**1995 No. 3107**

**The Traffic Signs (Amendment)  
Regulations and General Directions 1995**

**THE TRAFFIC SIGNS (AMENDMENT) REGULATIONS 1995**

DIAGRAMS TO BE INSERTED INTO THE TRAFFIC SIGNS REGULATIONS 1994 SCHEDULE 7 PART IV

2324

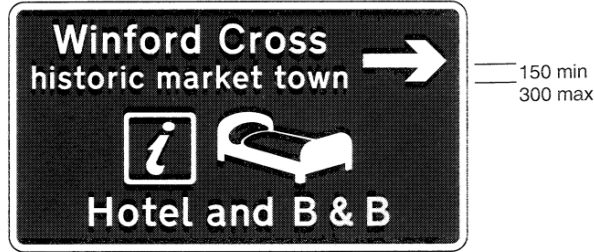
- (b) after diagram 2323 there shall be inserted diagrams 2324 to 2329, together with the captions and tables beneath those diagrams, as set out in the Schedule to these Regulations.

Junction ahead leading to serviced accommodation

Item	
1	Regulations: None
2	Directions: 12 (3)
3	Diagrams: None
4	Permitted variants: Schedule 16, items 3, 6, 12, 19, 28, 29, 33 The name may be varied to a generic description of the serviced accommodation
5	Illumination requirements: Schedule 17, item 9

Direction to serviced accommodation

Item	
1	Regulations: None
2	Directions: 12 (3)
3	Diagrams: None
4	Permitted variants: Schedule 16, items 3, 6, 15, 19, 28, 29, 33 Same as diagram 2324
5	Illumination requirements: Schedule 17, item 9

Junction ahead leading to refreshment facilities

Item	
1	Regulations: None
2	Directions: 12 (3)
3	Diagrams: None
4	Permitted variants: Schedule 16, items 3, 6, 12, 19, 29, 33 The spoon and fork symbol may be varied to the cup symbol shown in diagram 2327. The name may be varied to a generic description of the refreshment facilities
5	Illumination requirements: Schedule 17, item 9

Direction to refreshment facilities

Item	
1	Regulations: None
2	Directions: 12 (3)
3	Diagrams: None
4	Permitted variants: Schedule 16, items 3, 6, 15, 19, 29, 33 The cup symbol may be varied to the spoon and fork symbol shown in diagram 2326. Same as diagram 2326
5	Illumination requirements: Schedule 17, item 9
